X 91.132-26

## MODEL 262 G

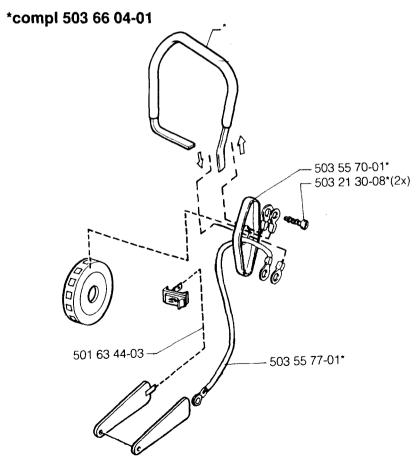
The front handle is now equipped with a terminal and an interchangeable lead in order to receive an easier assembly. See ill.

In order to receive full interchangeability the lead, terminal and screw are delivered with the front handle.

New ref. no.	Description	Excluded ref. no.
503 66 04-01 503 55 70-01 503 21 30-08	Front handle, kit Terminal 2 screws	503 54 01-04
503 55 77-01	Lead

Introduced from serial number 1480070
